LAND CRUISER (70 series)

OUTLINE OF NEW FEATURES

The following changes are made for the new Land Cruiser (70 series).

Oxidation Catalytic Converter

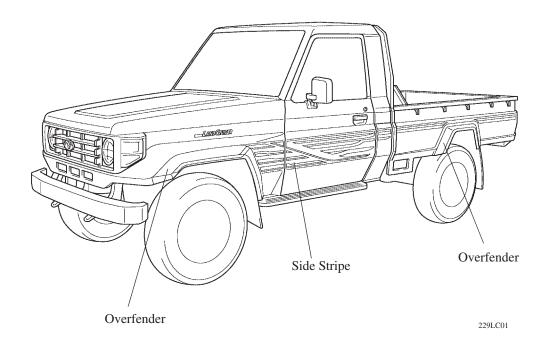
An oxidation catalytic converter has been provided on the model for Australia to comply with the European STEP-II regulations. No change for the engine output or torque occurs in accordance with this change.
